Fifth Gen Cascadia Turn Signal/DRL

Affected Models:
Fifth Generation Cascadia

Fig. 4, Front Radar Removal

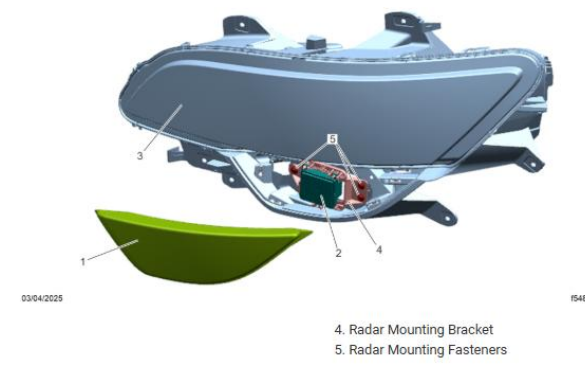
Use **suction cup pullers to firmly pull out and remove the LH side radome. Remove the side radar mounting fasteners, then remove the LH side radar unit. See Fig. 4.
